Addendum #5

Bid Opportunity: CPS-RFT-25-03 - North Paris Fire Station

PROJECT: North Paris Fire Station

ADDENDUM 01

DRAWN: KF

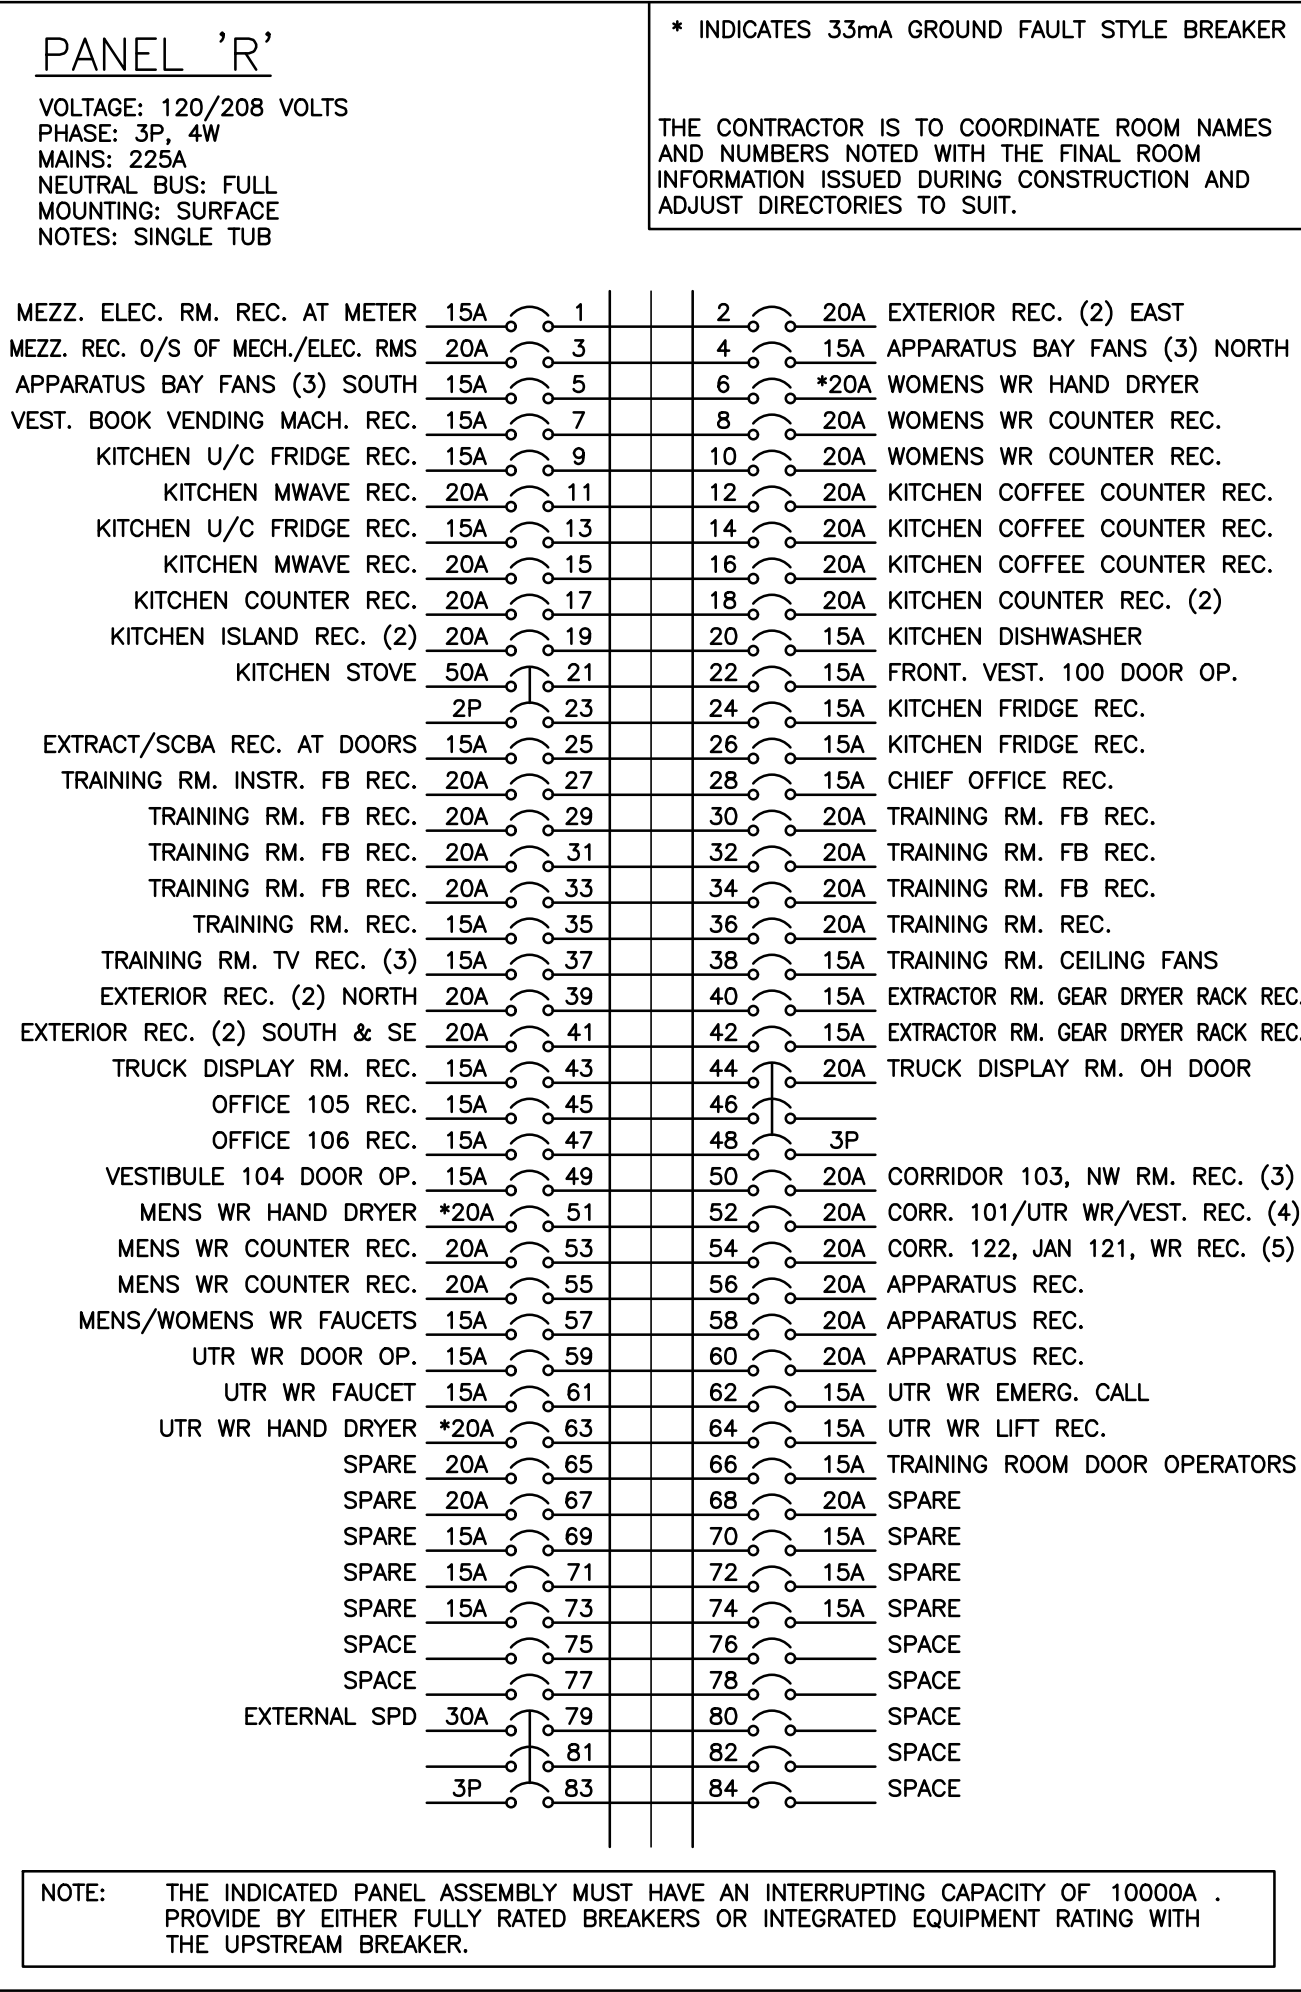
Question 2: 2. There is an incoming main telecom backboard, but there is a note stating there is “conduit for fiber to pole splice enclosure” (detail c, drawing E301). Please provide more information. Where are the two 12-strand lines going, there is one entering the bottom of the data cabinet in the network room shown on drawing E601, and there is also another existing the incoming main telecom backboard. Please provide clarification.

- 4.0 Reference Attached Reissued Drawing E301
 - .1 On Plan 'C' (Network Rm 108 enlarged plan) delete the 1-78mmC for fibre to pole splice enclosure as indicated on attached reissued drawing E301.

E402

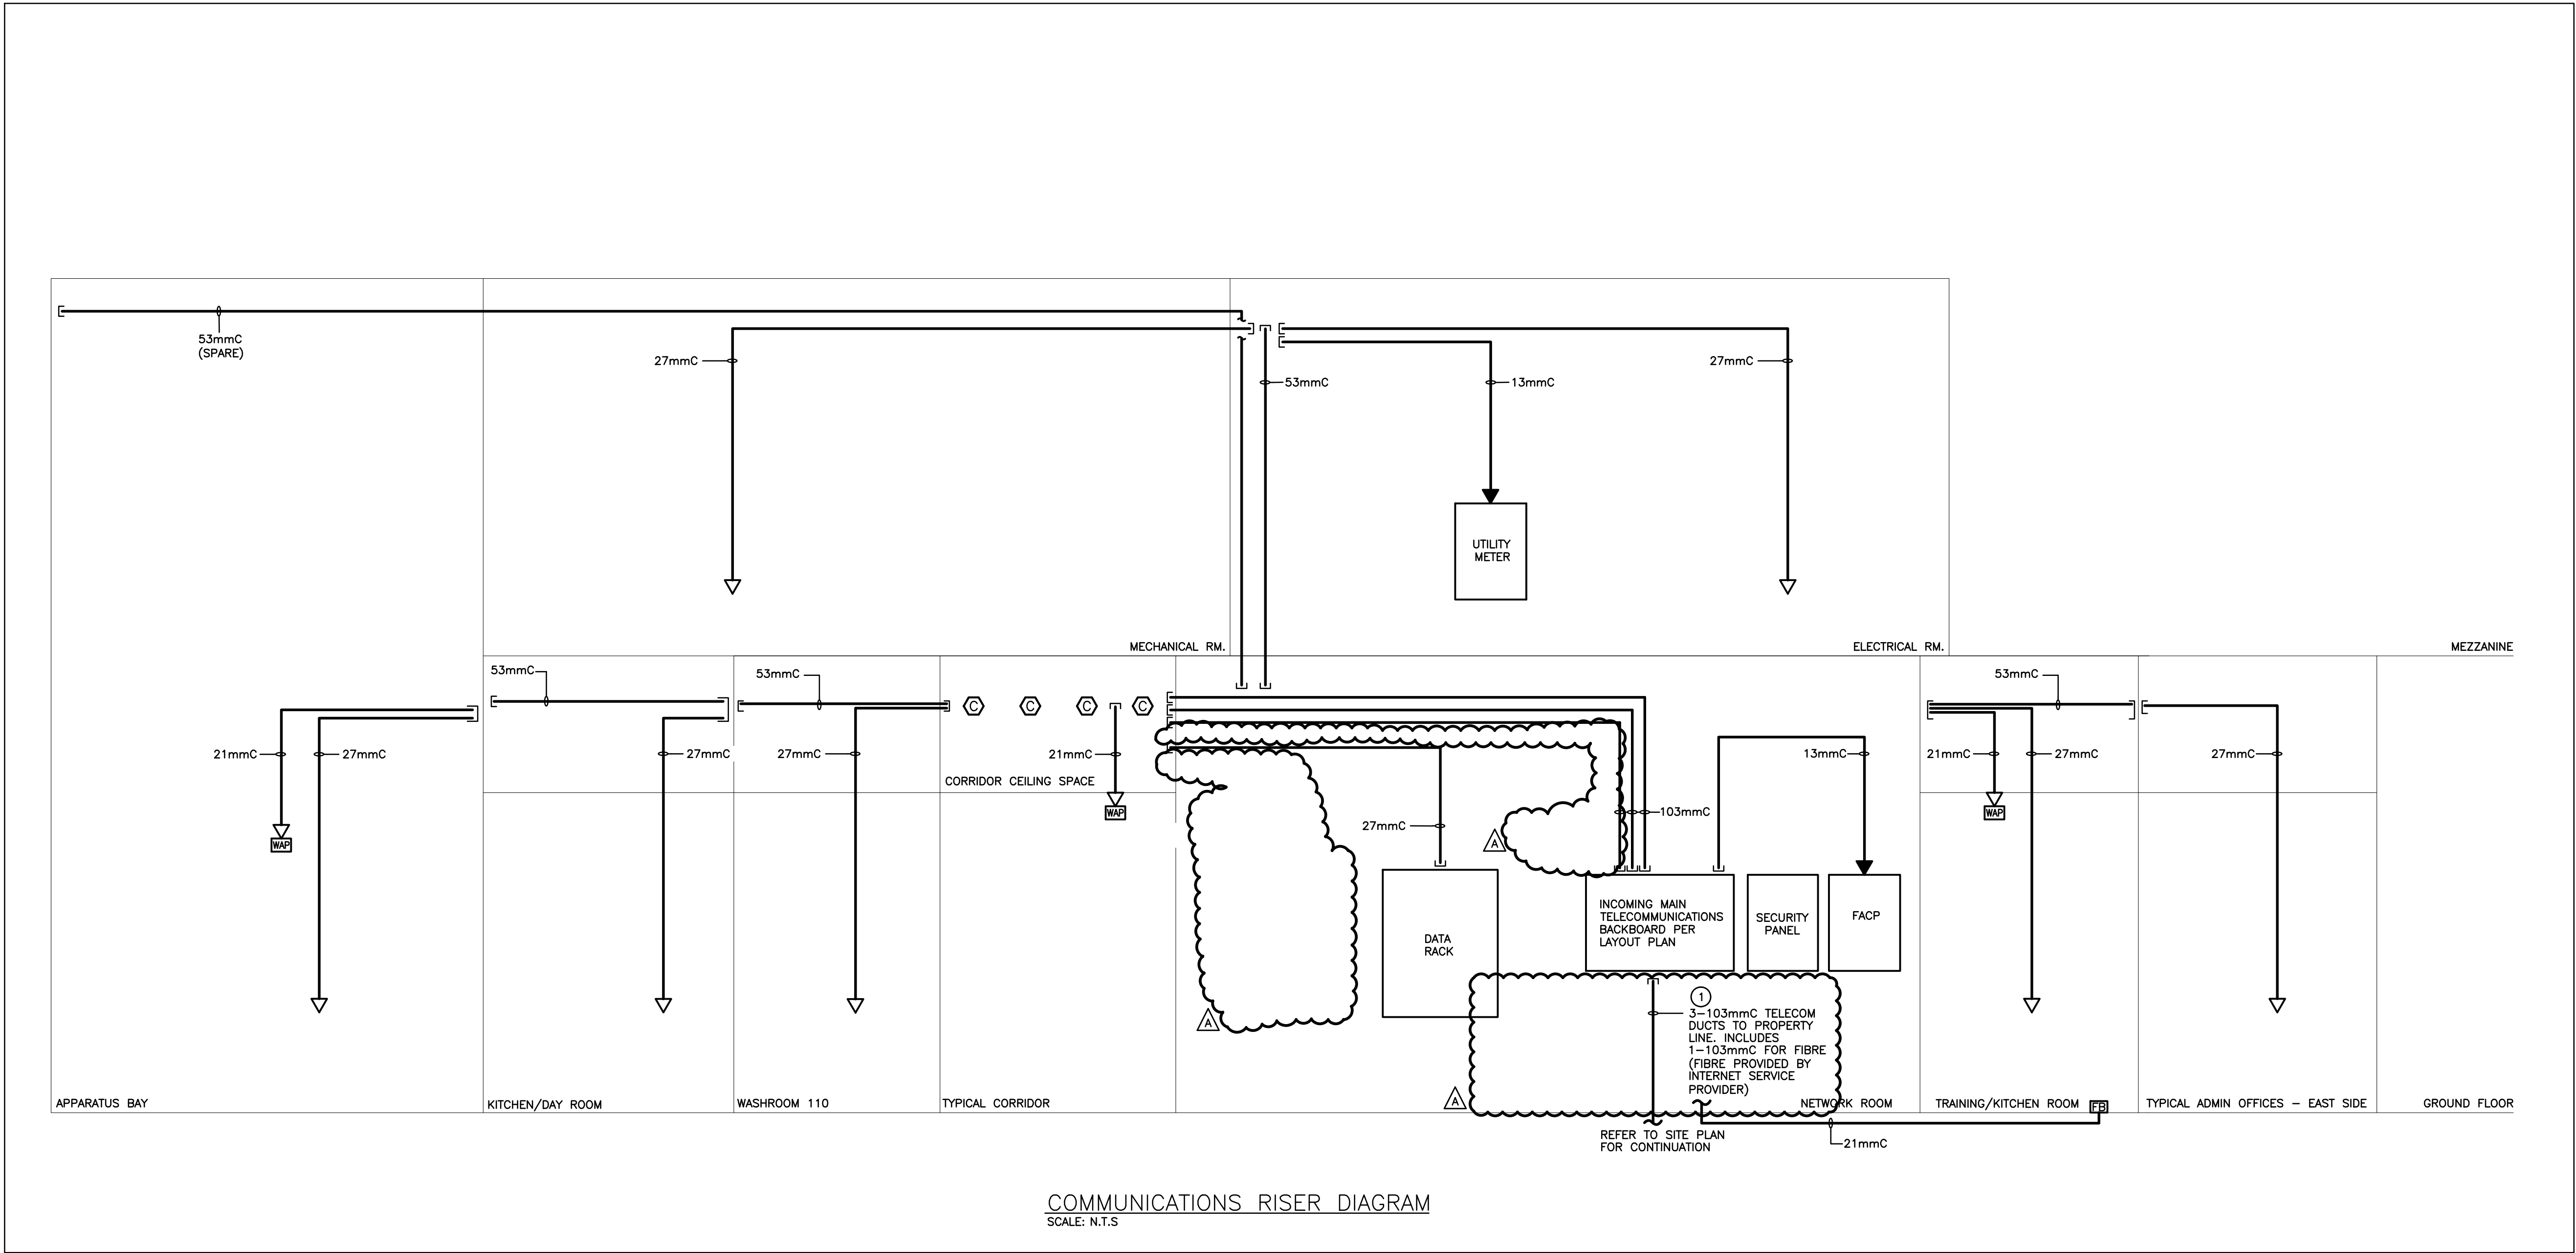
- 6.0 Reference Attached Reissued Drawing E402
- .1 In Panel Schedule 'M', the spare 15A-1P circuit 'M-37' to be labelled as 'Domestic Recirc Pump RP-2', as indicated on attached reissued drawing E402.
